MODIFICATION RECOMMENDED

6574A-10

S E R V I C E N O T E

6574A DC POWER SUPPLY, 0-60 V, 0-35 A, 2100 W. MANUALLY CONTROLLED.

Figure 3 Regal Non locking Nut

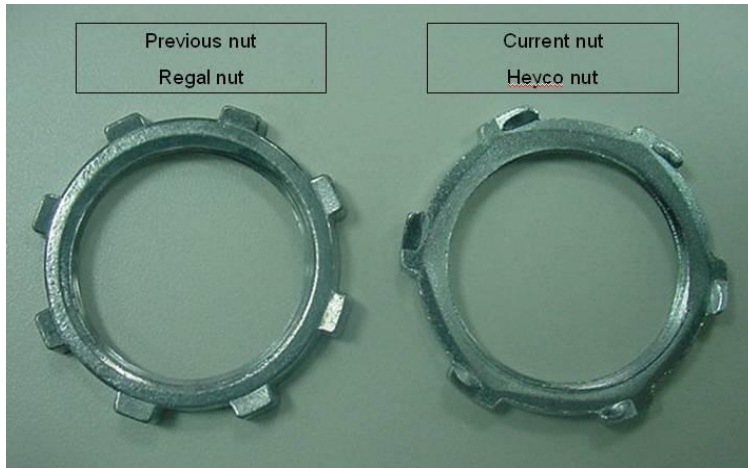
Figure 2 shows the inside of the AC Safety Cover housing the incorrect hardware is shown. It will be very difficult to tighten the strain relief. AMC (Asian Manufacturing Center) uses a special tool to tighten the locking nut. When the incorrect nut is used or a locking Nut is put on incorrectly the strain relief will become loose as described above.

Figures 3 & 5 is representative of a not without locking ribs.

Figures 4 & 6 is representative of a nut with locking ribs.

The entire AC **INPUT SAFETY COVER** P/N 5040-1676 should be replaced.
